National Committee on Uniform Traffic Control Devices

TTC Technical Committee Recommendations

Approved by the NCUTCD Council January 2008 & June 2008

Figure 6H-1. Examples of Traffic Incident Management Area Signs

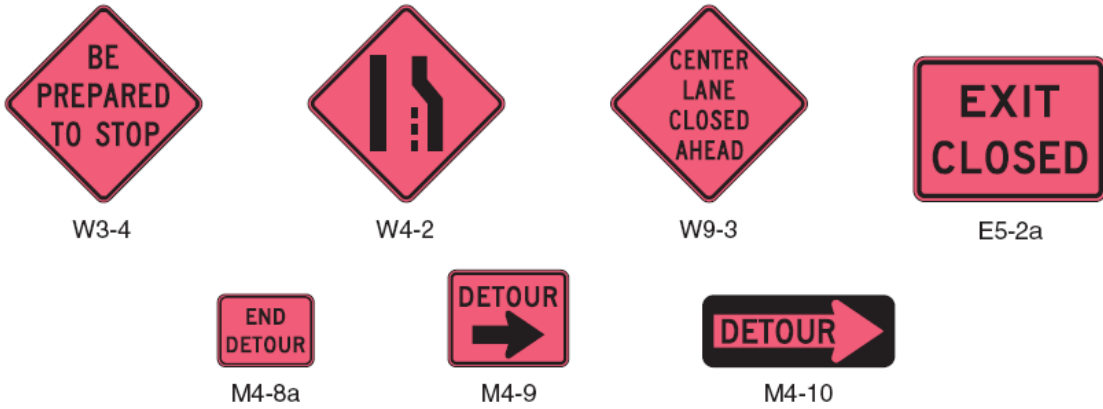
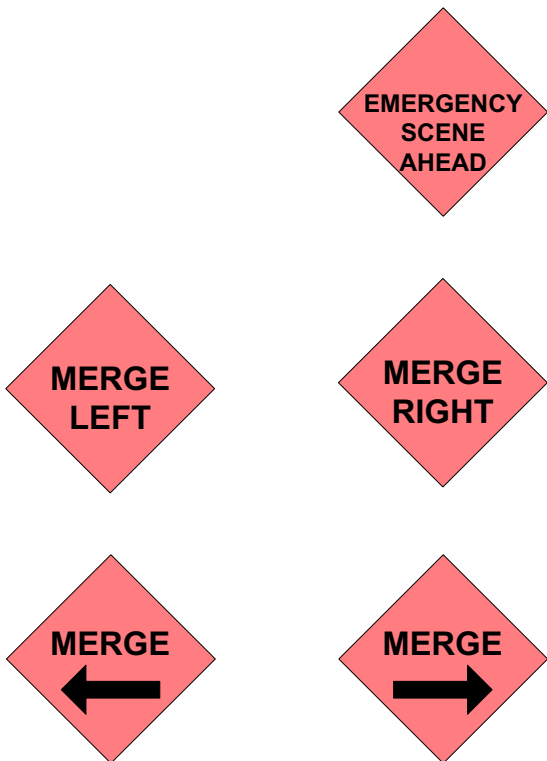
NPA Did Not Change the Figure, but TTC voted to add the following:

insert diamond signs: "EMERGENCY SCENE AHEAD" and "MERGE RIGHT/LEFT"
